**Moorebank Avenue – Anzac Road (MAAI)
Works: Phase 2A**

Post-Opening Road Safety Audit Report

March 2024

PHOTOS 1 & 2: For the pedestrian crossing across Moorebank Avenue (north) (top photo) as well as across the Moorebank Avenue southbound left-turn slip-lane into Anzac Road (bottom photo), there are no 'hold' lines to guide and separate pedestrian waiting areas from adjacent live traffic lanes.

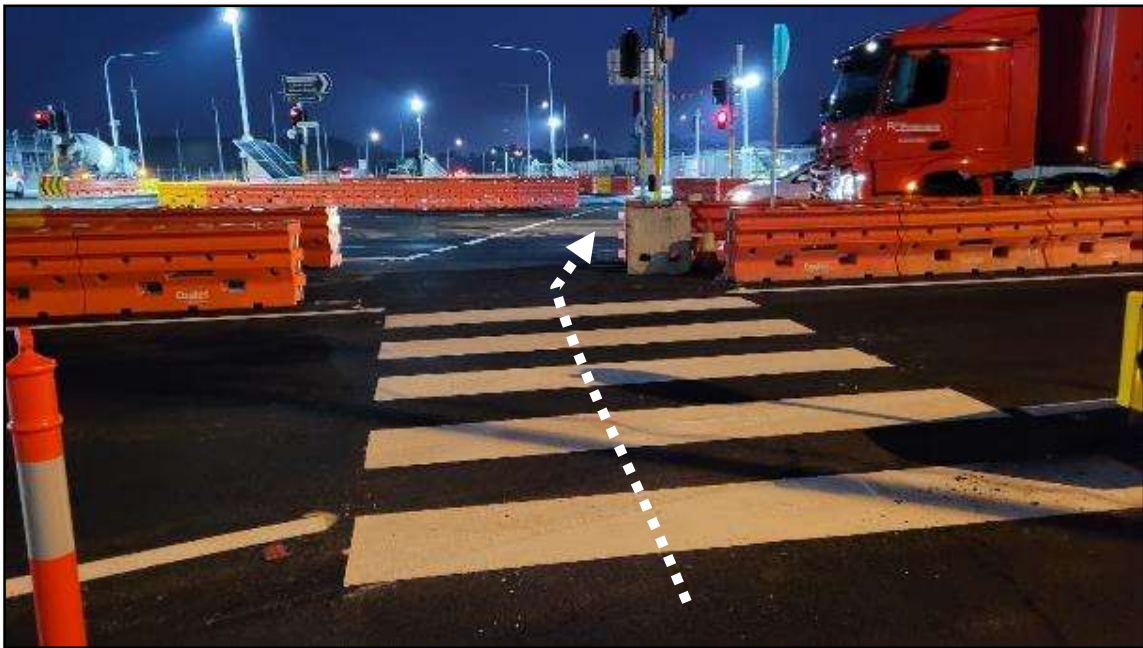
<i>For completion by BMD</i>	
No.	Description of Road Safety Issue	Risk Rating	Road Safety Category	Action by	Response	
1.	For some of the pedestrian crossing legs, there are no 'hold' lines to guide and separate pedestrian waiting areas from adjacent live traffic lanes – refer to <i>Photos 1 and 2</i> in <i>Appendix A</i> . This includes the marked pedestrian crossing across the Moorebank Avenue southbound left-turn slip-lane into Anzac Road.	Medium - High	Pedestrian infrastructure	Northrop BMD	<p>Linemarking of 'hold' lines to be implemented to delineate edge pedestrian waiting areas and adjacent live traffic.</p> <p>Completed on 25/03/2024</p>
